# Technical Service Information

## NISSAN RL4F02A FLARE 2-3 SHIFT OR NO 2-3 SHIFT HOT

Figure 1

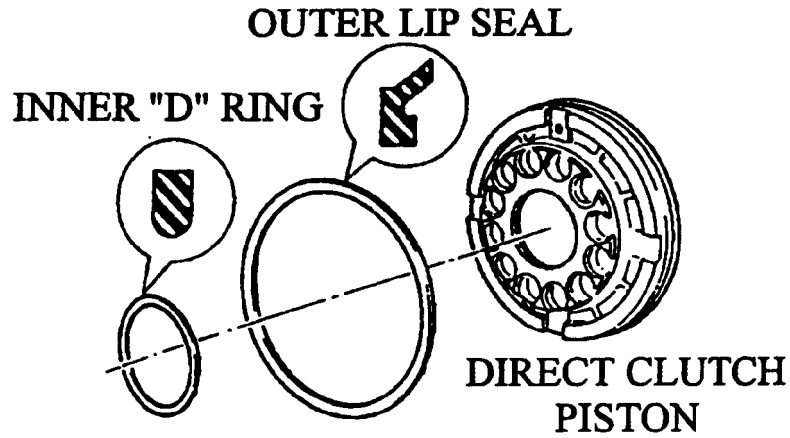
**CAUSE:** NO. (1) - It has been determined that the inner "D" ring on the direct clutch piston wears badly and/or shrinks, creating a leak of direct clutch oil at the inner seal (See Figure 1).

**CORRECTION:** NO. (1) - Remove the outer lip seal from the direct clutch piston and install the piston back into the direct drum with only the "D" ring in the piston. Rotate the piston and check the "D" ring for "Drag", as shown in Figure 3. "D" ring wear and/or shrinkage is what normally creates this complaint, and simply replacing the "D" ring solves the problem.

Figure 2

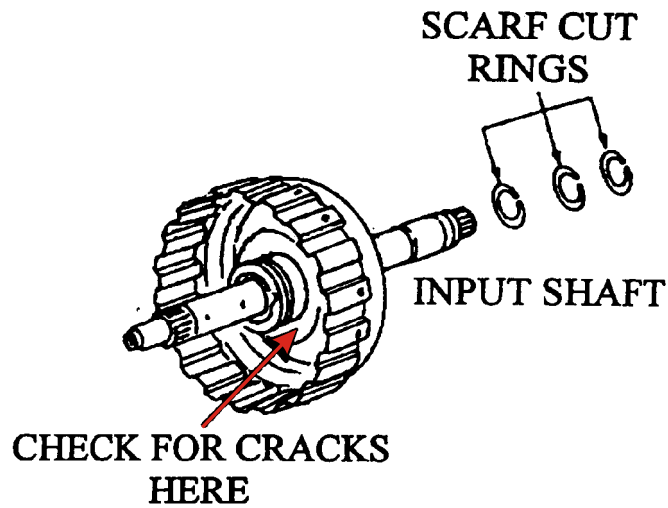
NO. (2) - It has also been found that the direct drum is prone to cracking in the area around the inside diameter of the drum where the input shaft is attached to the drum, and is sometimes difficult to see visually (See Figure 2).

NO. (2) - If when checking the "D" ring for "Drag" as explained above, you determine the "D" ring DOES have sufficient "Drag", then a close inspection of the direct drum for cracks, in the area shown in Figure 2, is MANDATORY. Replace the direct drum as necessary.

NOTE: ATSG has found that the Chrysler A04/413 scarf-cut Teflon seal rings provide much better sealing of direct clutch oil, when they are used on the input shaft in this unit (See Figure 2).
